From: John Marshall [john@jmarshalllaw.com]
Sent: Wednesday, July 25, 2012 2:31 PM
To: Van Bussum, Monica
Subject: Re: Water bank application maps
Attachments: Map 02-2262 1.pdf

I've attached a map we put together for the water bank application for 02-2186. Before we get going on the others, I wanted to make sure something like this is acceptable. Also, with regard to 02-2262, because of its permissible place of use and digital boundary, is a map required for this right?

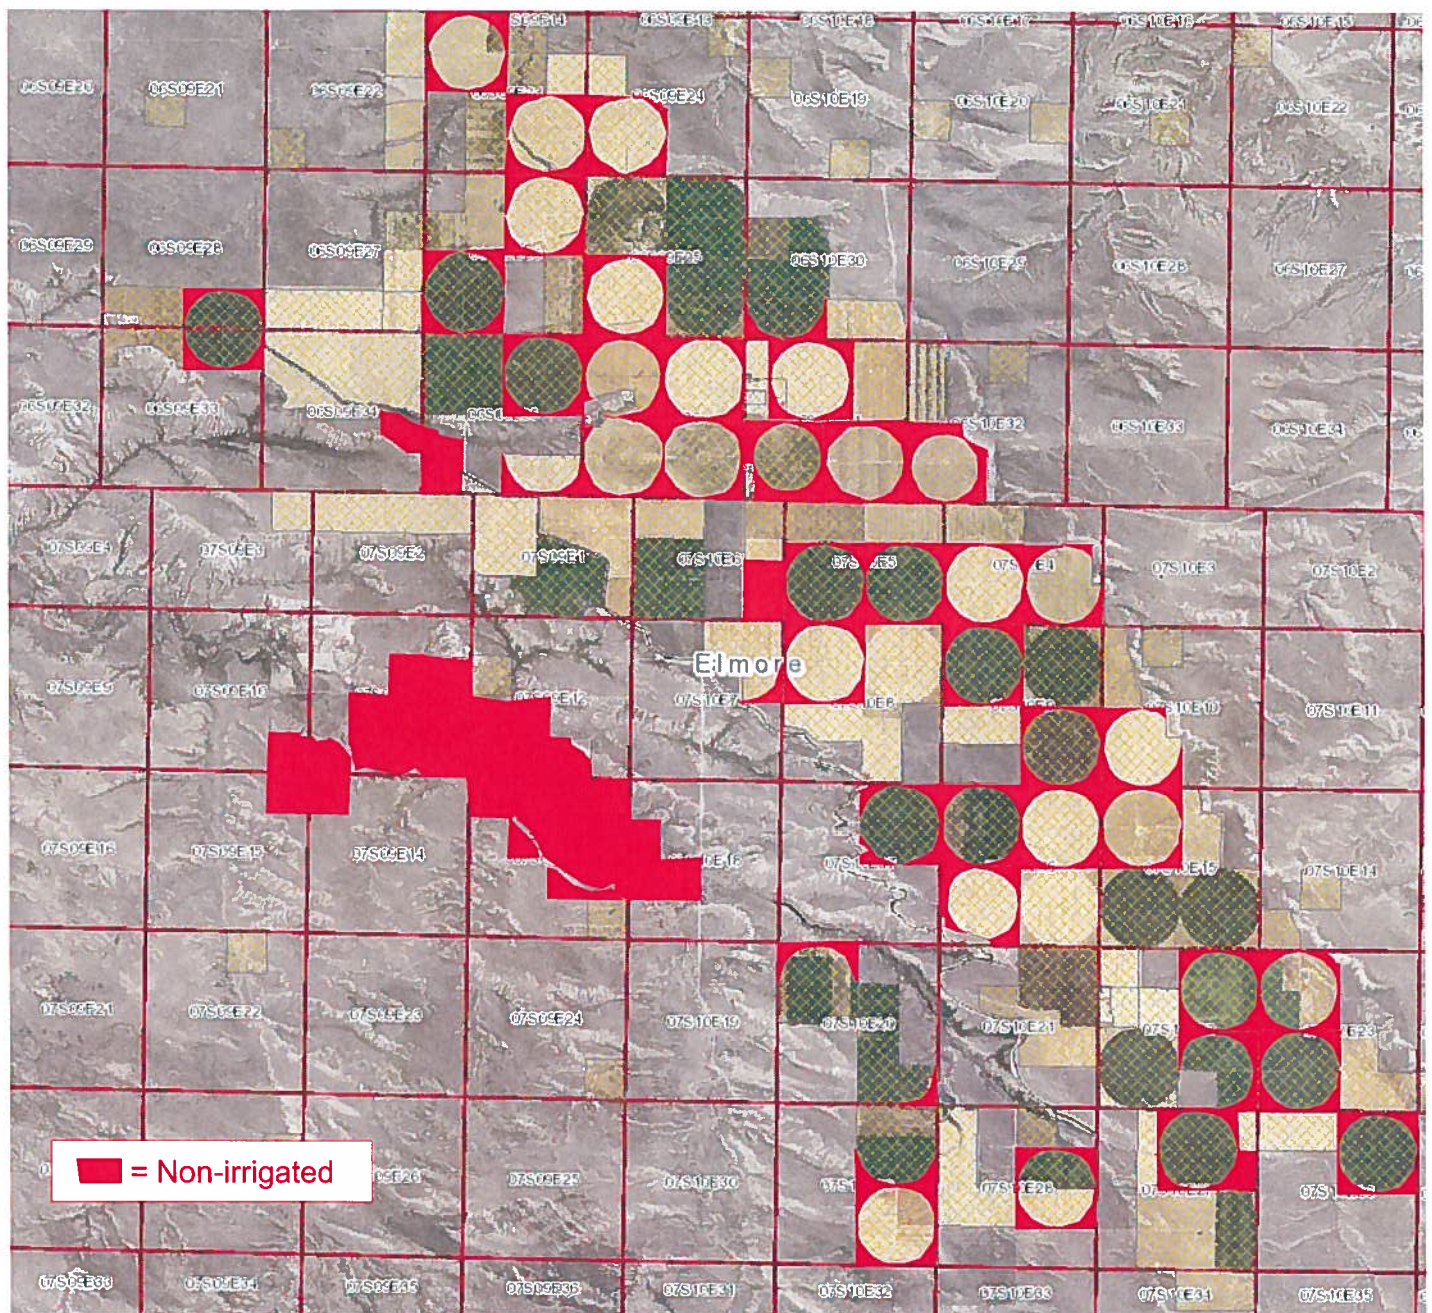
This map looks really good. I would only ask for a map legend so the record is clear the acres in orange are the ones offered. As to 2-2262, that is a really good question and one we've had several occasions to discuss over here. I have spoken with Director Spackman on a couple of occasions about this type of situation and have confirmed the Department needs a map showing idled acres, even from an irrigation district with a PPU. I can talk more in-depth about it if you would like.
